Union Electric

ULNRC-04861  
TAC No. MB6478

DOCKET NUMBER 50-483  
CALLAWAY PLANT  
UNION ELECTRIC COMPANY  
REVISION TO TECHNICAL SPECIFICATION 5.5.9  
"STEAM GENERATOR (SG) TUBE SURVEILLANCE PROGRAM"  
References: 1) ULNRC-04745 dated October 3, 2002  
2) NRC letter to G. L. Randolph dated February 4, 2003

REQUEST FOR ADDITIONAL INFORMATION  
RELATED TO STEAM GENERATOR TUBE INSPECTION LICENSE AMENDMENT  
UNION ELECTRIC COMPANY  
CALLAWAY PLANT, UNIT 1  
DOCKET NO. 50-483

Figure Q65-1  
Callaway Non-axial Tubeshet Indications (Below -0.3" from TTS)

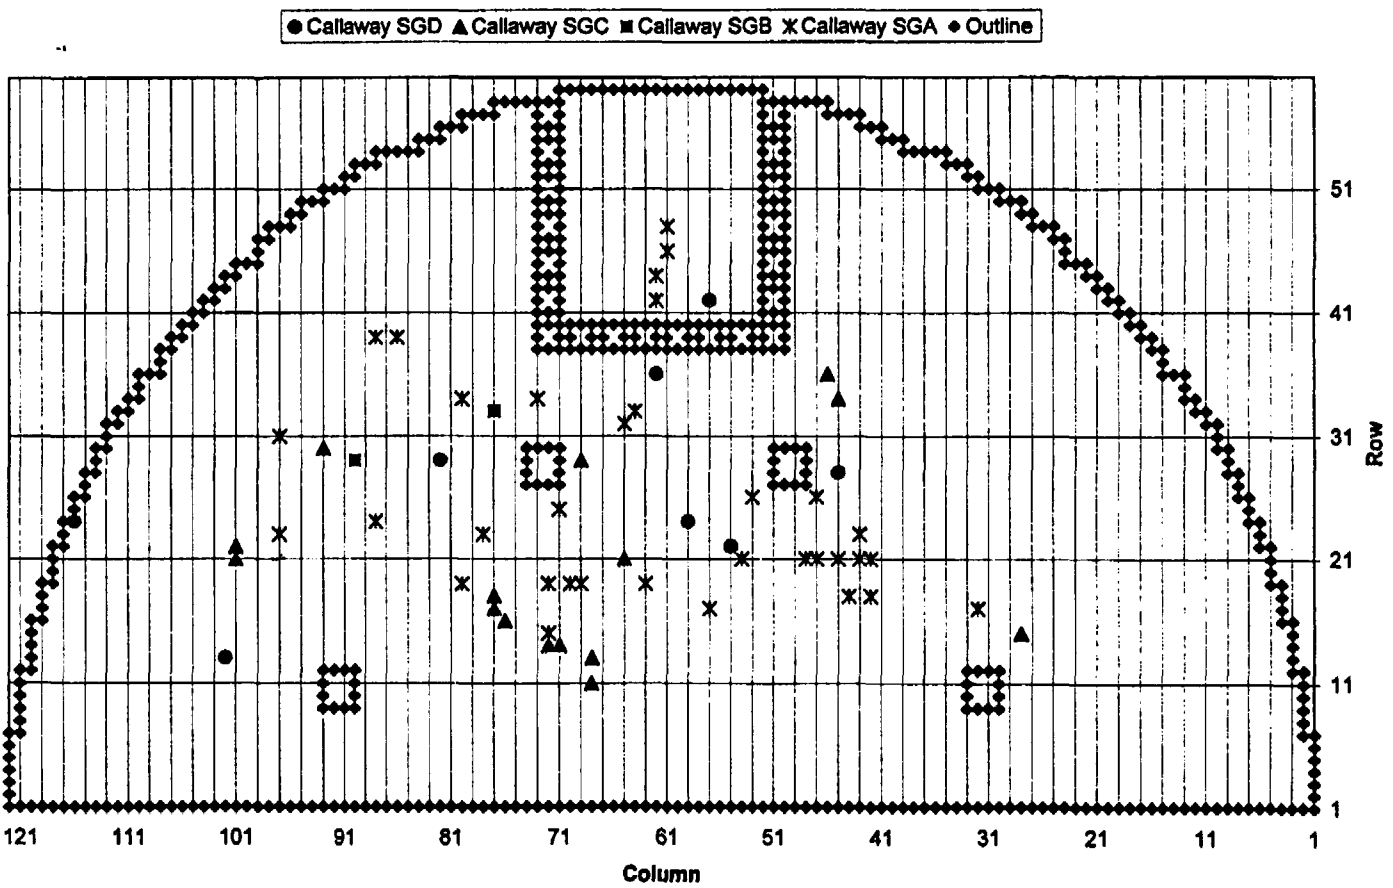
*65. Regarding Figure 14 in the Westinghouse report, SG-SGDA-02-47, and the determination of the distribution of indications below the inspected region, it is not apparent that the methodology presented supports the conclusion that the distribution of indications below the H\* distance is uniform, for the following reasons:*

*Replot Figure 14 based on all indications (regardless of severity, zone, or outage in which they were detected) and also with all indications in specific zones to assess whether the uniform distribution assumption still holds.*

A tubesheet map of Callaway non-axial tubesheet indications below -0.3 inches from the top of the tubesheet is provided in Figure Q65-1. The plot supports a determination that the indications are distributed uniformly in the radial direction outside the thermally treated portion of the tube bundle and part of Zone A. Figure 6.14, "Distribution of Severe Indication Locations" of WCAP-15932, Rev. 1 supports a uniform distribution along the elevation of the tubesheet.
